SIGHT DISTANCE:

WORKS 1

Works 3

18-09-2020 TSD-RF01-v3

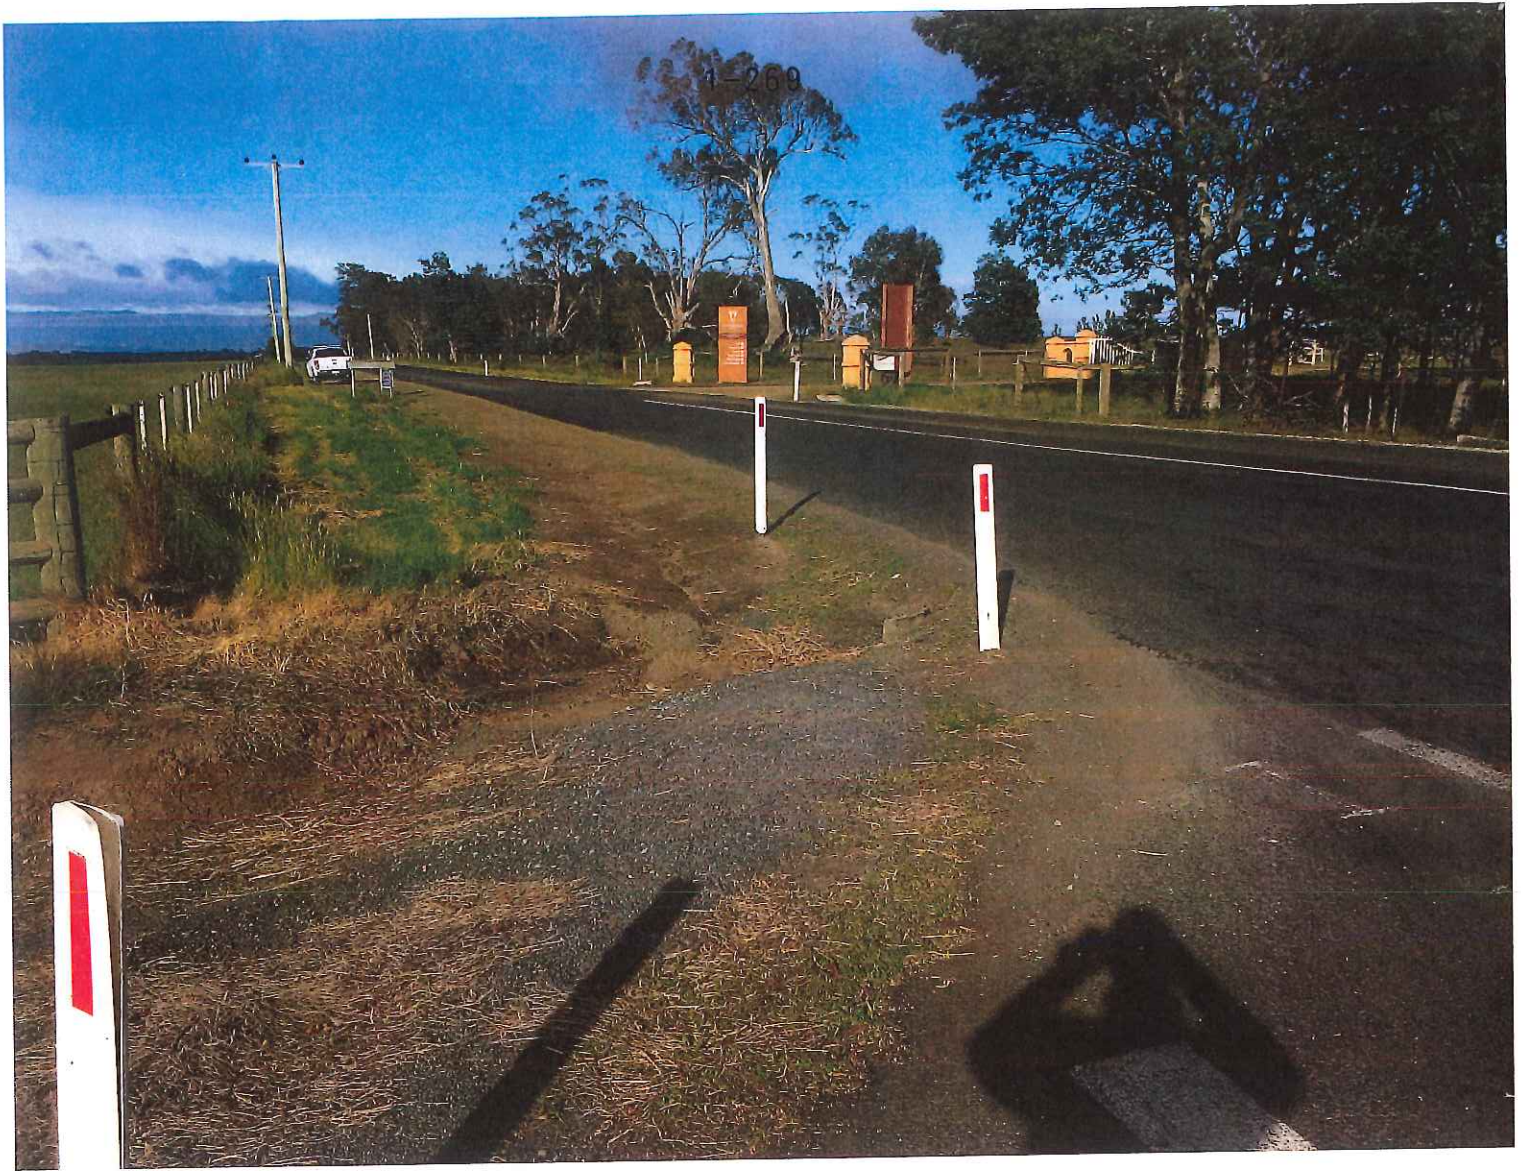
SISD from the attached LGAT-IPWEA standard for a 100km/hr vehicle speed on a new road with speed limit above 60 km/hr is preferable at 250m (without specific consideration).
